**RE: Lot 11 Block 1 Volcano Cliffs Unit 22 SAD 228
8004 Alto Rey Ct. NW
Grading and Drainage Plan
Engineers Stamp Date: 10/29/2020 (D10D003N11)
Pad Certification Date: 5/10/21**

Based upon the information provided in your submittal received 5/14/2021, this plan cannot be approved for Grading Permit until the following comments are addressed.

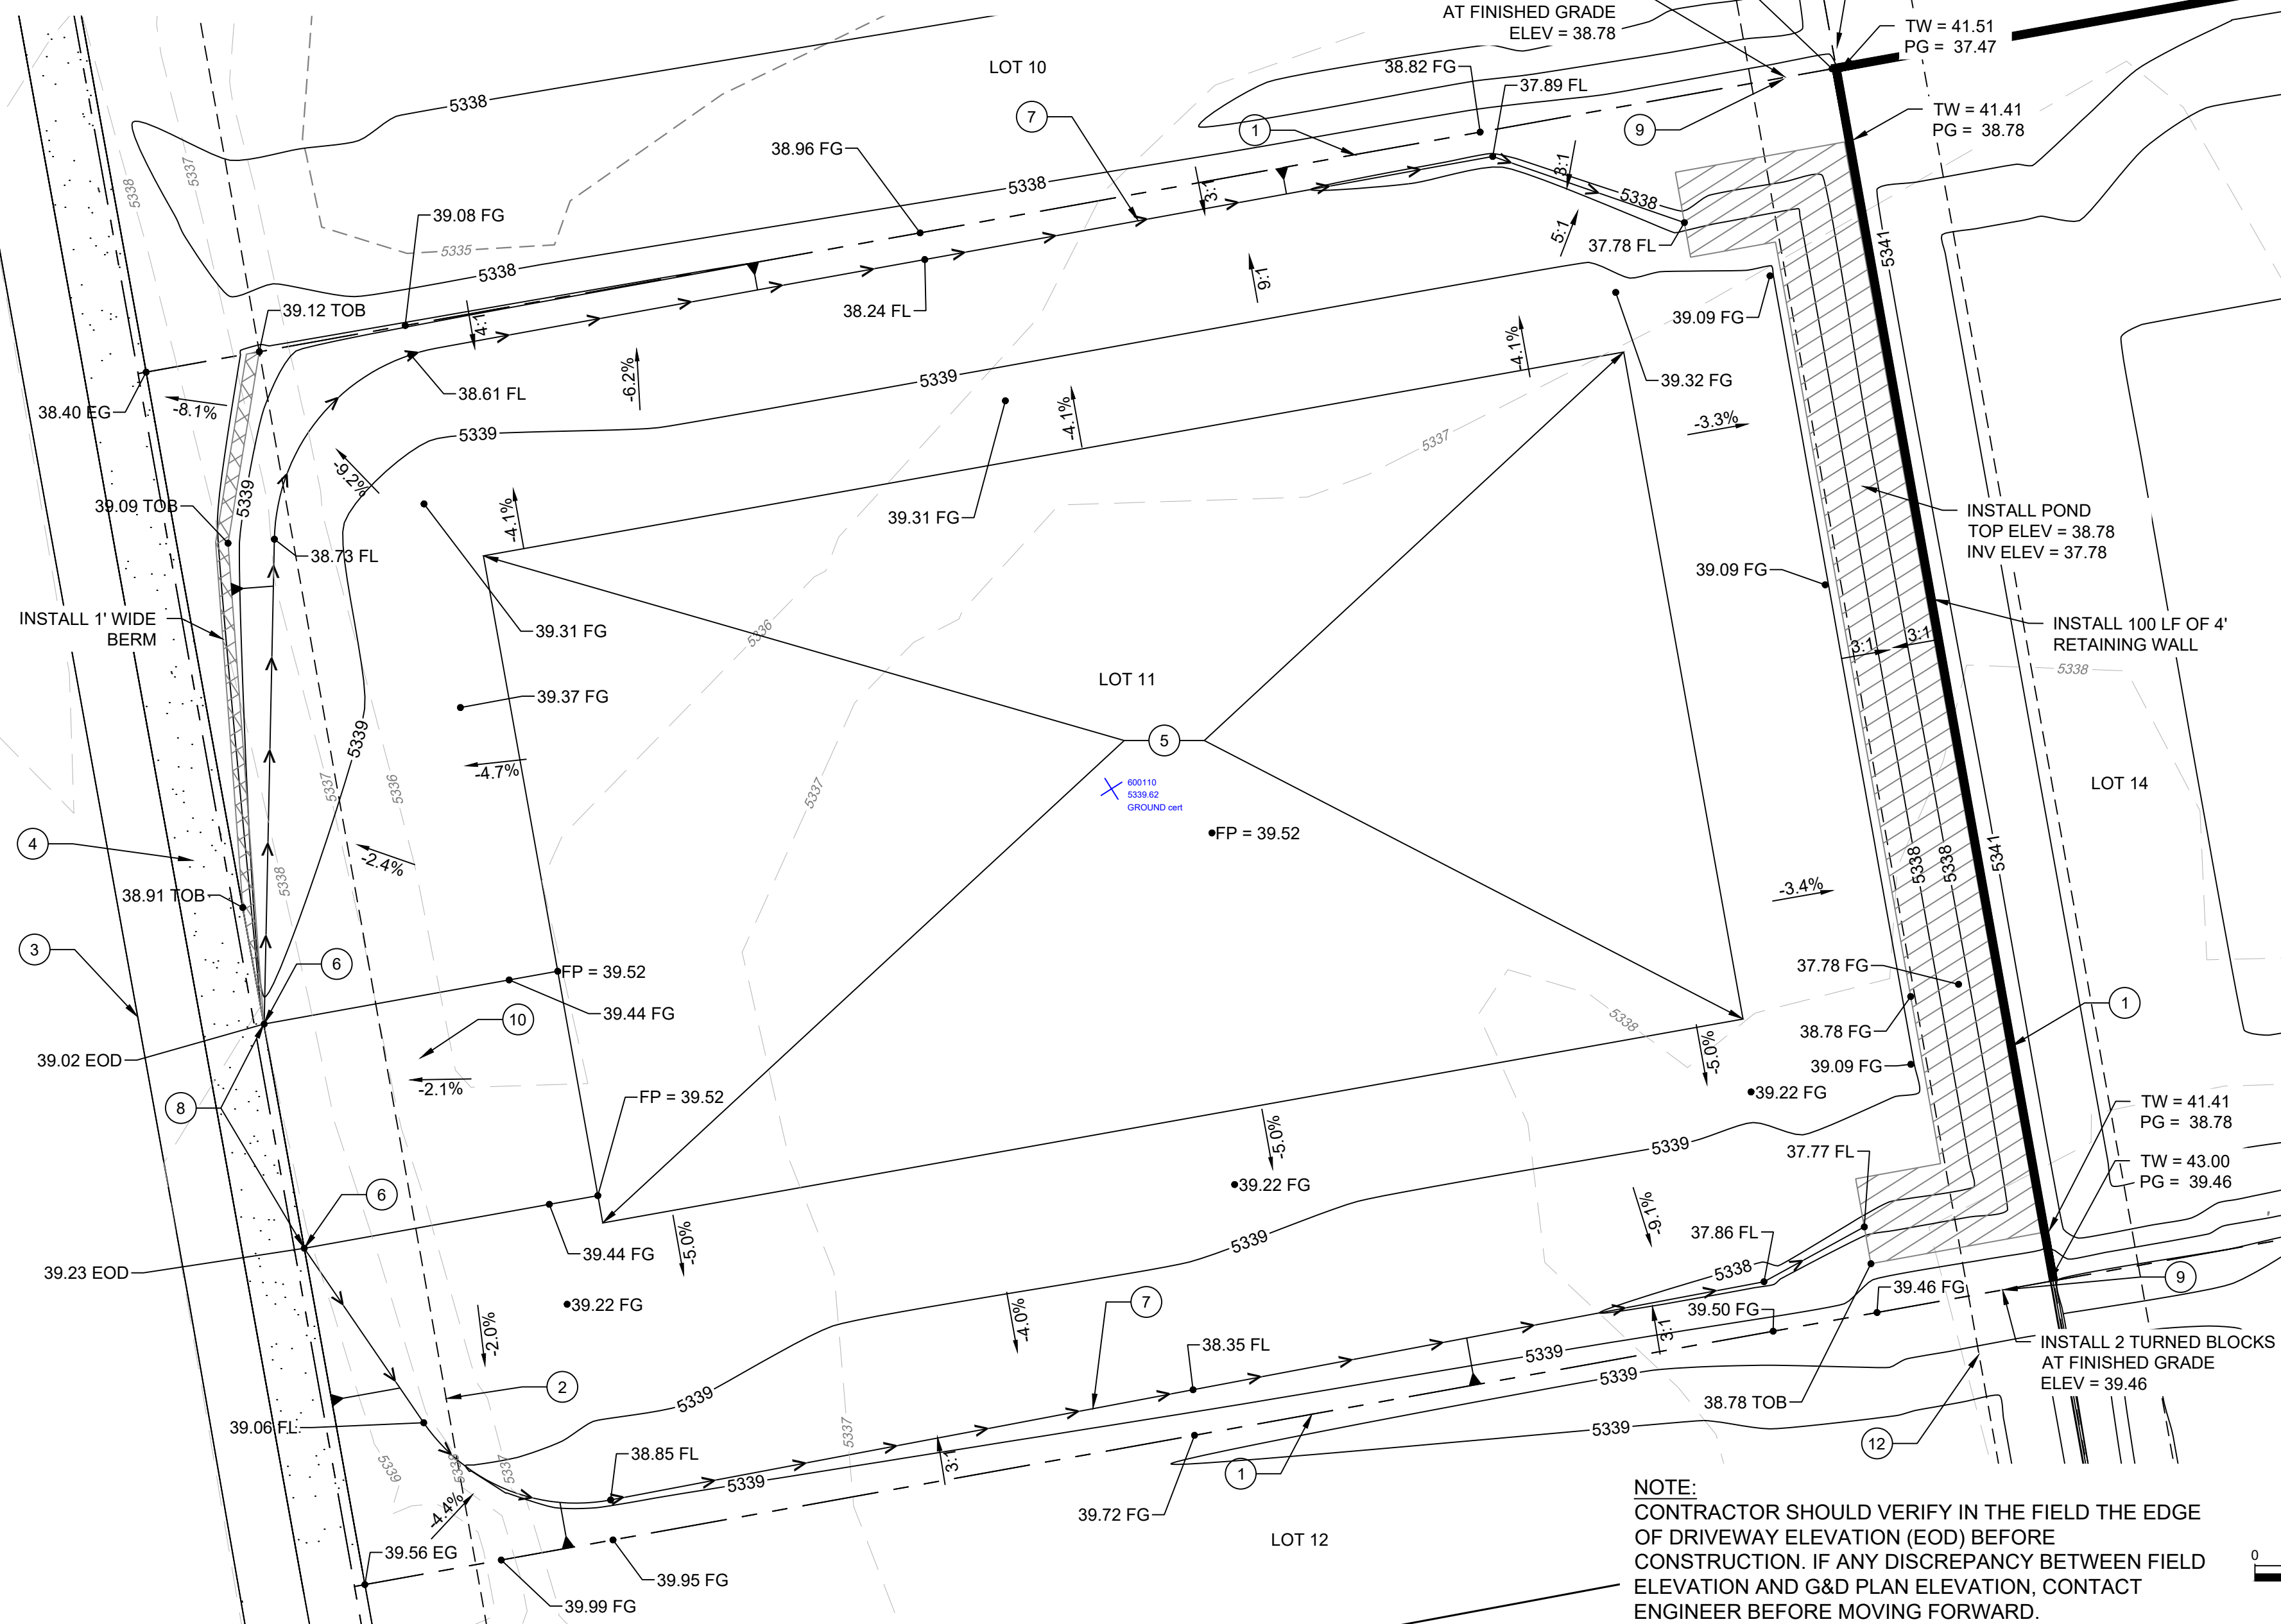
- Provide the approval letter or email given by Doug Hughes.
